SOLICITATION AMENDMENT
MODIFICATION DE L'INVITATION

Title - Sujet New 96 Bed Living Unit - PIRTC	
Solicitation No. - N° de l'invitation EZ899-123081/A	Amendment No. - N° modif. 001
Client Reference No. - N° de référence du client	Date 2012-04-24
GETS Reference No. - N° de référence de SEAG PW-\$PWY-005-6657	
File No. - N° de dossier PWY-1-34503 (005)	CCC No./N° CCC - FMS No./N° VME
Solicitation Closes - L'invitation prend fin at - à 02:00 PM on - le 2012-05-08	
F.O.B. - F.A.B. Plant-Usine: <input type="checkbox"/> Destination: <input checked="" type="checkbox"/> Other-Autre: <input type="checkbox"/>	
Address Enquiries to: - Adresser toutes questions à: Pillay, Sal (PWY)	Buyer Id - Id de l'acheteur pwy005
Telephone No. - N° de téléphone (604) 775-9386 ()	FAX No. - N° de FAX (604) 775-6633
Destination - of Goods, Services, and Construction: Destination - des biens, services et construction: CSC - Pacific Institution, Abbotsford, B.C.

Abbotsford, BC
Pacific Institution Regional Treatment Centre
New 96 Bed Living Unit

The following changes in the tender documents are effective immediately. This addendum will form part of the Contract Documents.

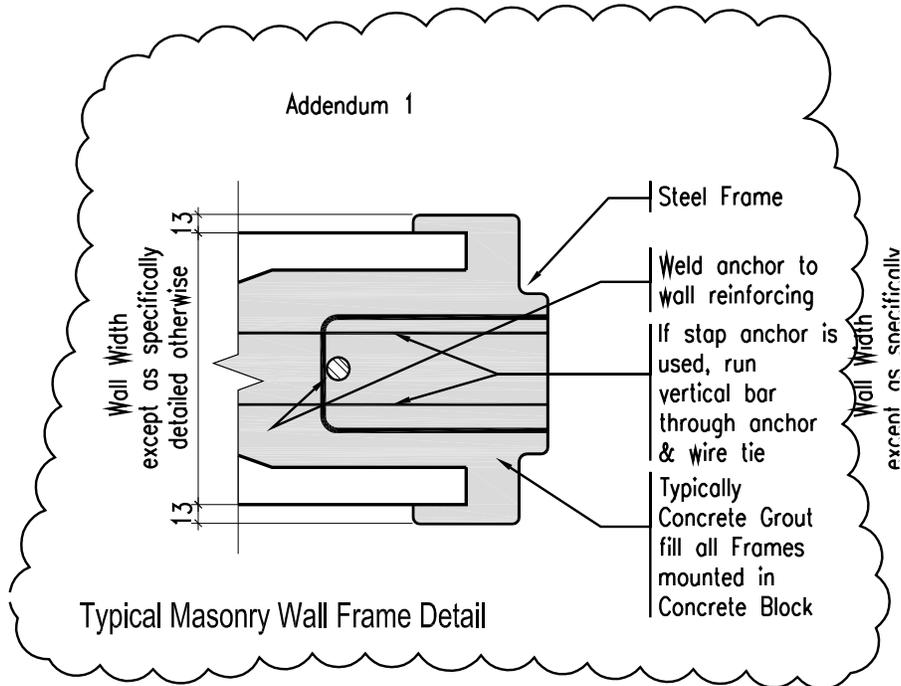
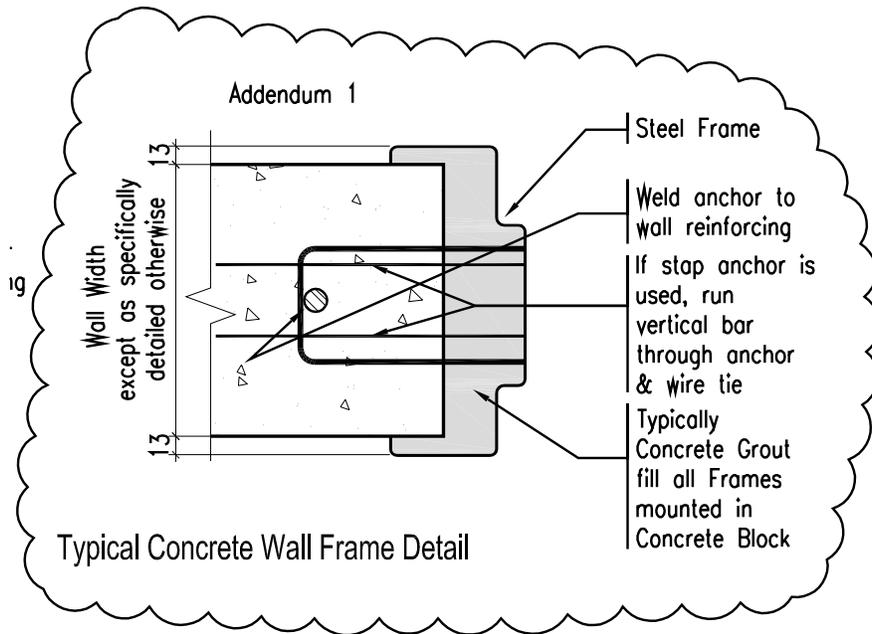
- 5.0 Drawing A703 Section 1 – Added Steel Plate thickness of Steel Curb. Refer to A1-09.
- 6.0 Drawing A900 Revise notes and Frame Detail. Refer to A1-01, A1-02, A1-03.
- 7.0 Drawing A100 Scope of Work to Existing Fence - clarifications Refer to A1-10, A1-11, A1-12 .
- 8.0 Drawing A010 Clarify Scope of new gravel parking pad. Refer to A1-13.

3. All Frames installed into Concrete Block or mounted in CIP Concrete, Concrete grout fill frame. Note modified details for doors installed into exterior walls.

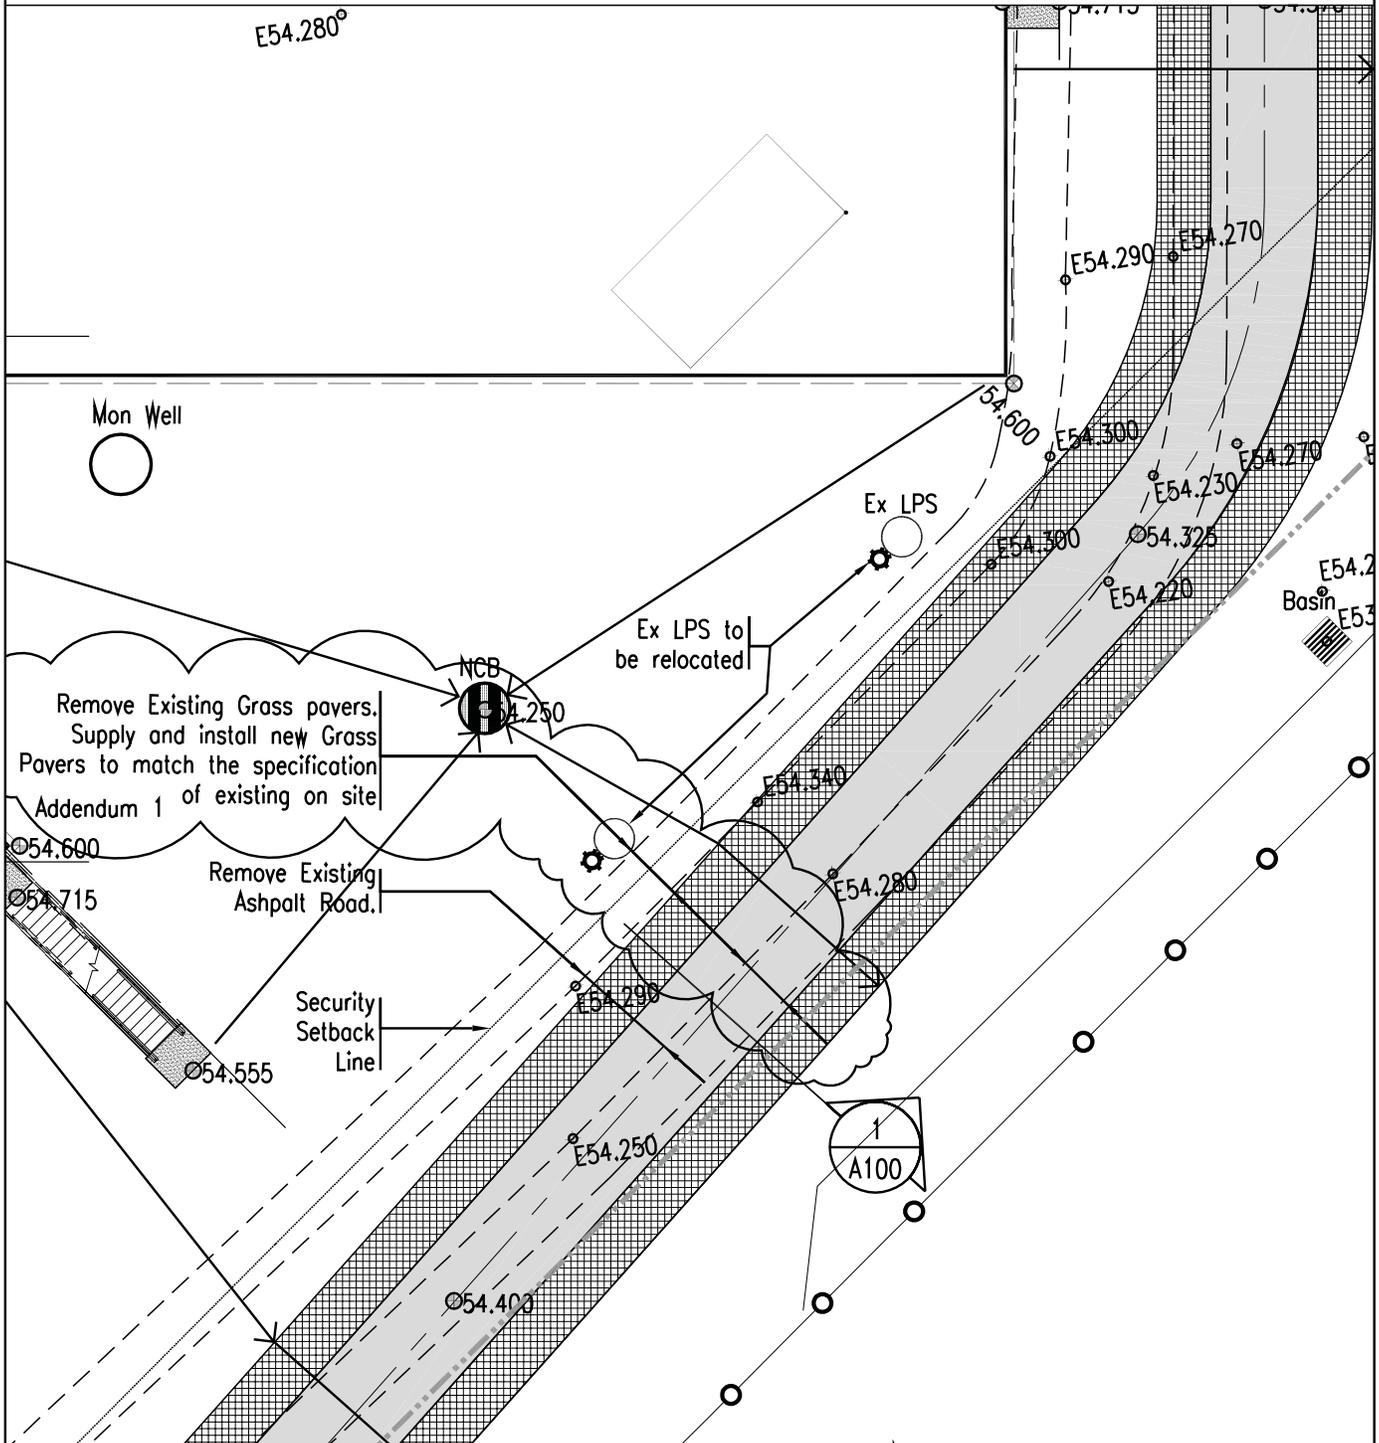
1.0 Drawing A100 Delete note to reinstall salvaged pavers. Supply and install new grass pavers. Product specification to match the existing on site for the area designated for grass pavers. Refer to A1-06, A1-07, A1-08.

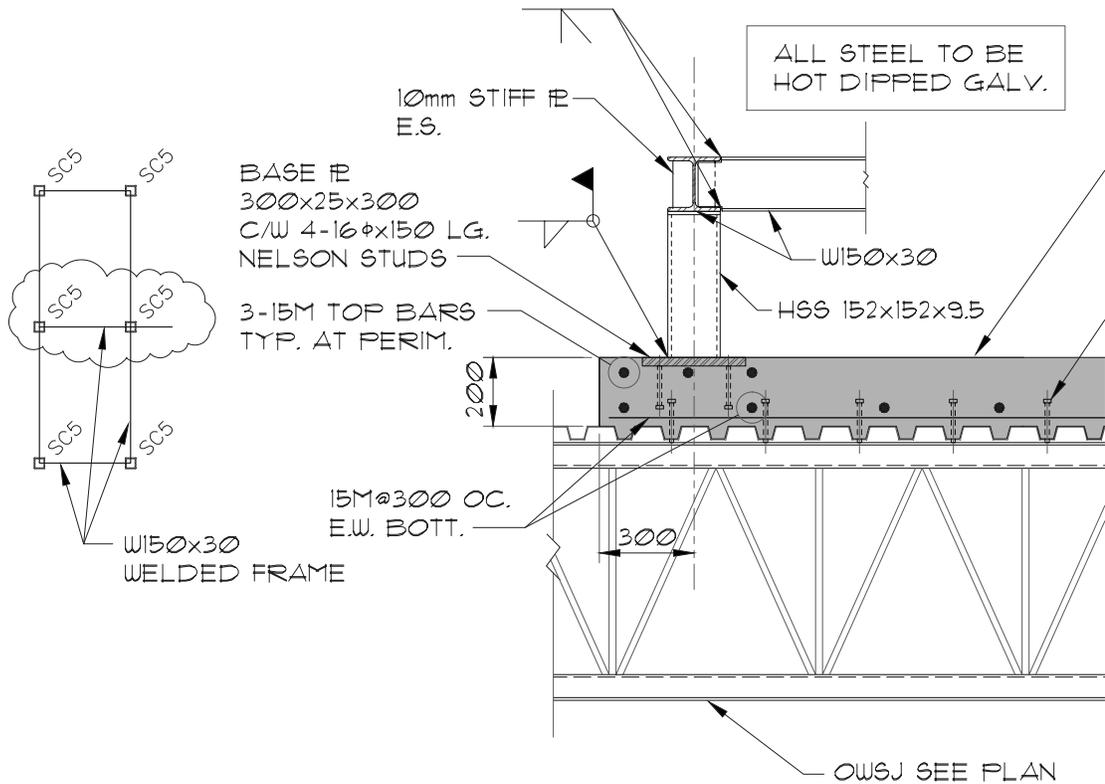
- Where do the W410x46 beams stop?
- How many joists are to be added?

The clouded area is existing framing

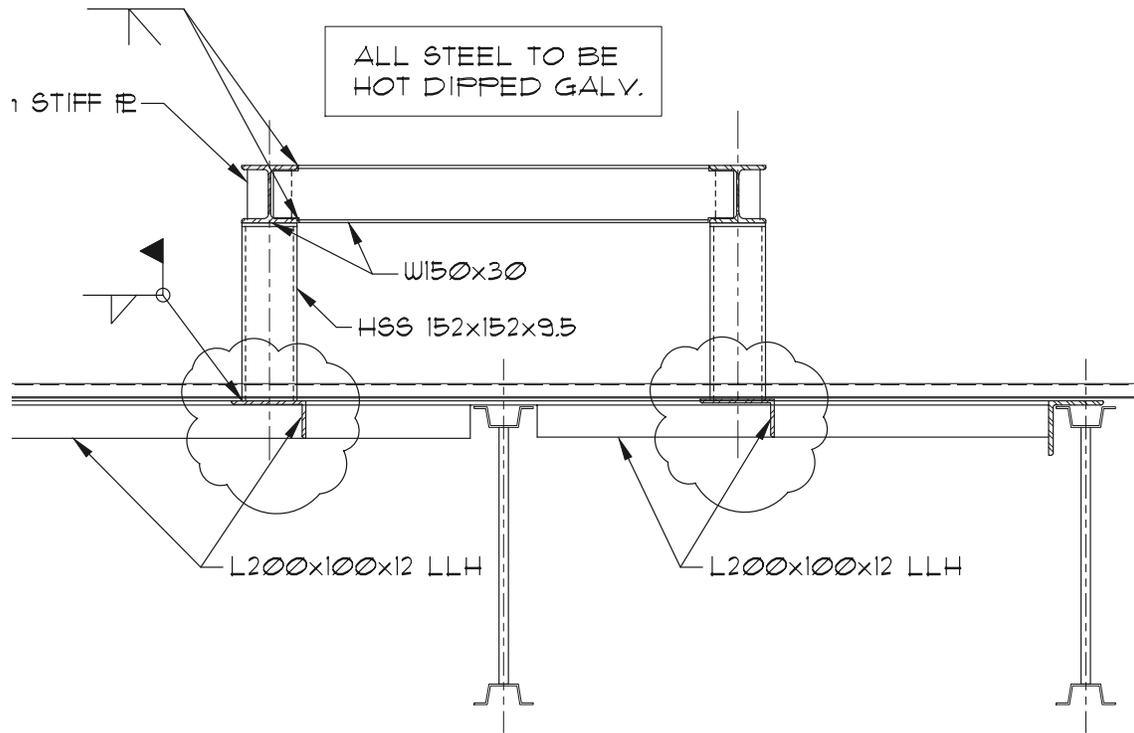
SECTION 20/2.02 REVISED AS SHOWN ABOVE

**SSK-
101**

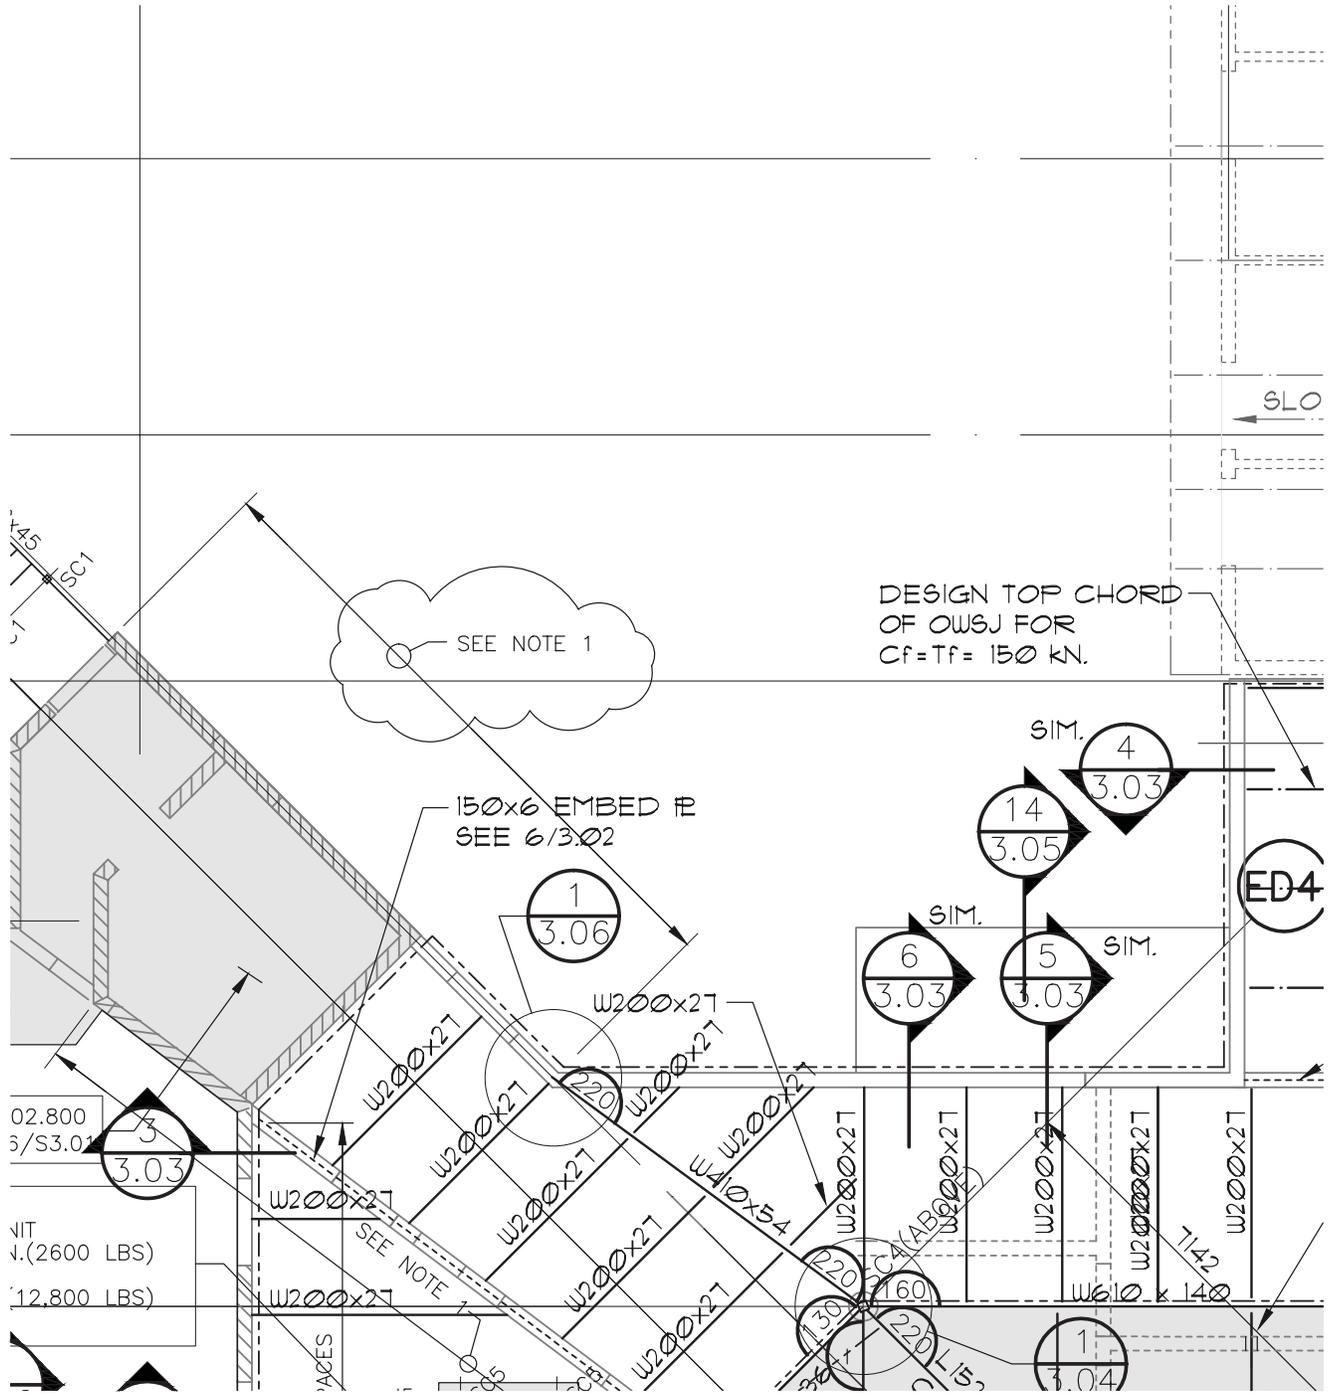
SECTION 21/2.02 REVISED AS SHOWN ABOVE

SSK-102

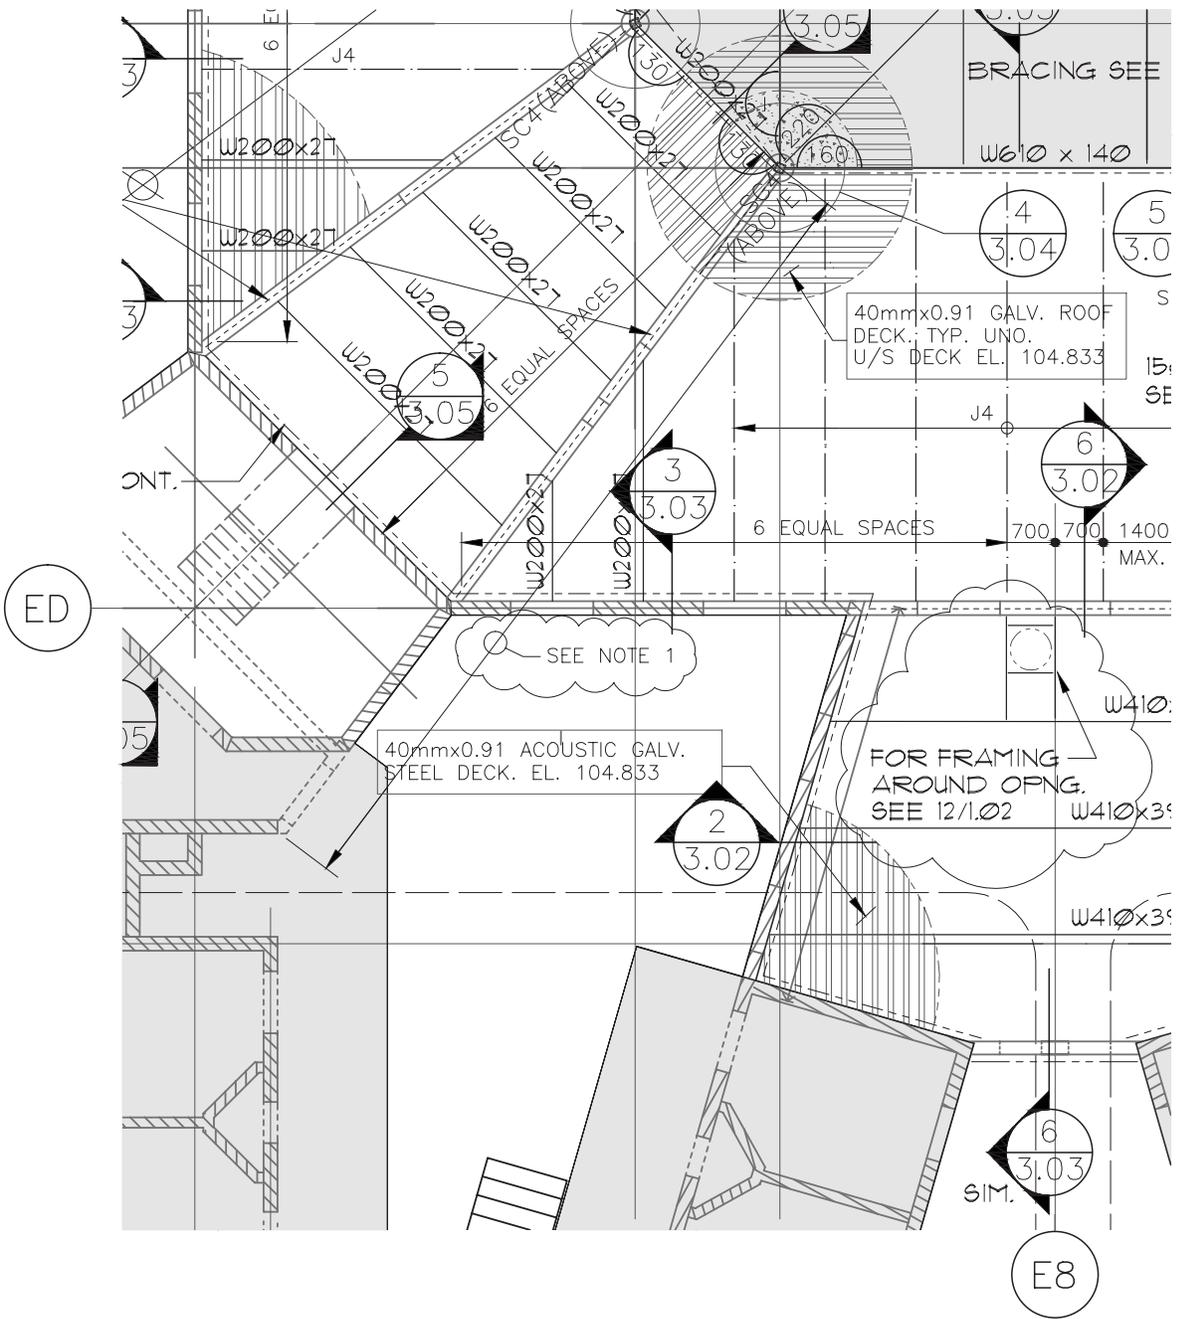
ON DWG. S2.02 NOTE 1 ADDED AS SHOWN ABOVE

ABBOTSFORD, B.C. PACIFIC INSTITUTION REGIONAL TREATMENT CENTRE	SHEET No. SSK- 103
--	------------------------------

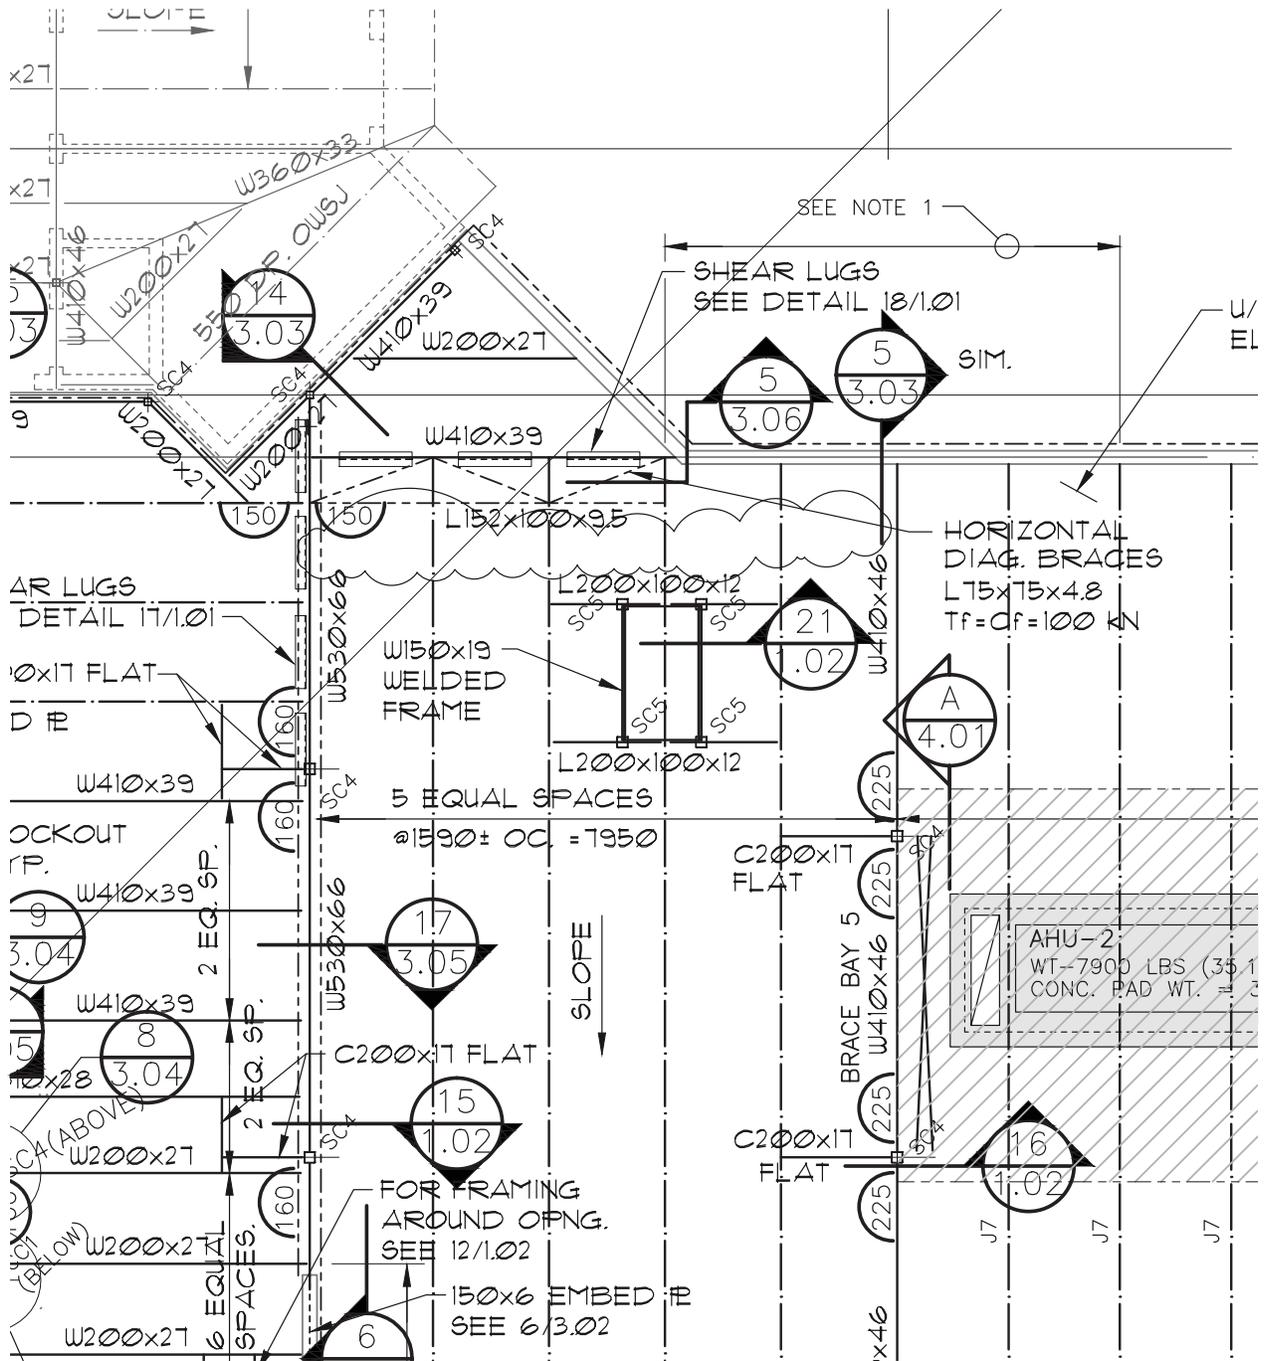
ON DWG. S2.02 NOTE 1 ADDED AS SHOWN ABOVE AND MECH. UNIT OPENING RELOCATED AS SHOWN ABOVE.

Clinic Service Sink

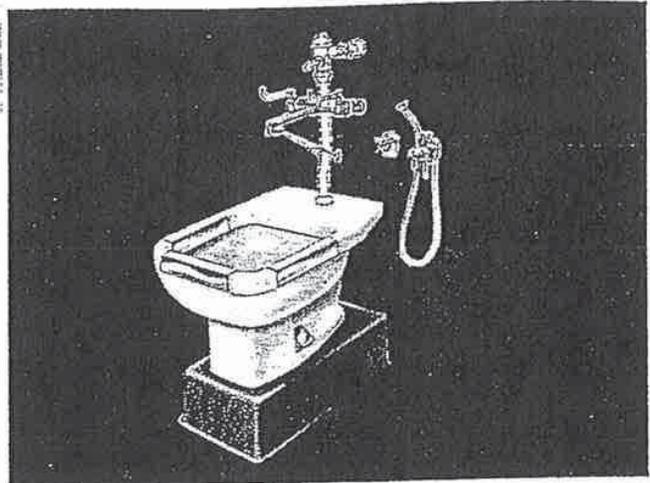
- 1.0 Drawing M2.01 In response to the RFI for make and model # for "MS-3" in room E1004-Jan shown on drawing M2.01. Revise sink label from "MS-3" to "MS-2" and refer to specification cut sheets attached for details of sink.
